Release Notes Voice Alarm System 3.01.01R1

Bosch Security Systems B.V.
PO Box 80002
5600JB Eindhoven
The Netherlands
www.boschsecuritysystems.com
12-October 2013
Page 1 of 10

Call station LBB1956 firmware

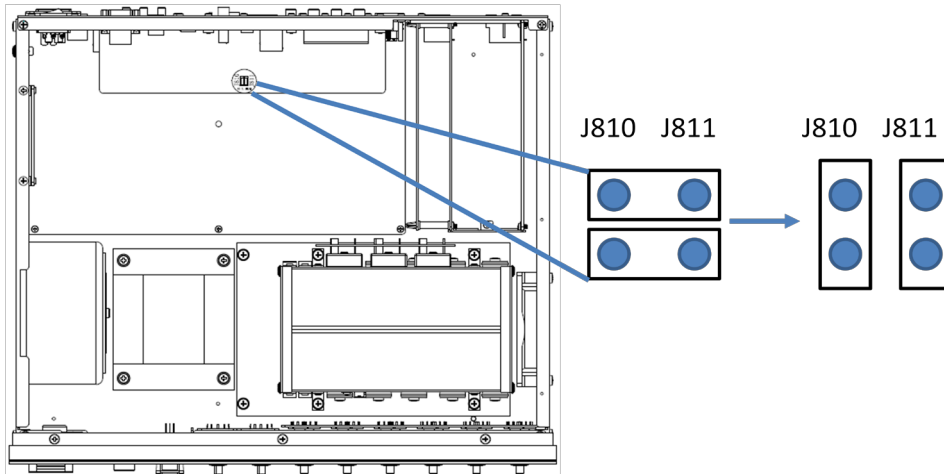
Call stations with older firmware than 3.01.01 will function normally when connected to controller with firmware 3.01.01 except for the new functionality of starting a message from the call station. Call stations with older firmware than 3.01.01 cannot be used to start a message from the call station. The call station firmware is not field upgradable. Call stations manufactured after 1-10-2013 have f/w 3.01.01.

Supervision of business trigger in H/W 2.0 & 3.0 - F/W 3.01.01

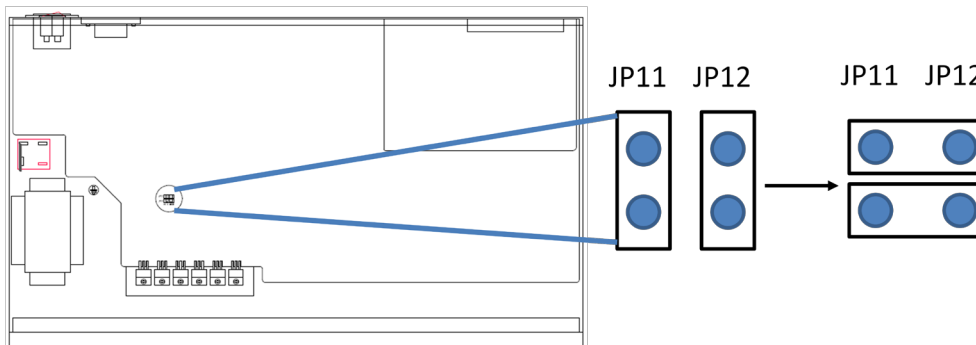
The jumpers J810 & J811 in the controller should be changed from horizontal to vertical.

The jumpers JP11 & JP12 in the router should be changed from vertical to horizontal.

With these changes, the business trigger inputs will become supervised.

- For H/W 2.0, 3.0 and 3.1
 - o To use F/W 3.00.xx or lower:
 the jumpers J810 & J811 in controller need to be placed horizontal.
 the jumpers JP11 & JP12 in router need to be placed vertical
 (there is no supervision of business triggers)
 - o To use F/W 3.01.xx,
 the jumpers J810 & J811 in controller need to be placed vertical
 the jumpers JP11 & JP12 in router need to be placed horizontal
 (Supervision of business triggers is possible)
- The factory default setting for 3.1 hardware. In controller is vertical and in router is horizontal.
- The factory default setting for 3.0 hardware. In controller is horizontal and in the router is vertical.
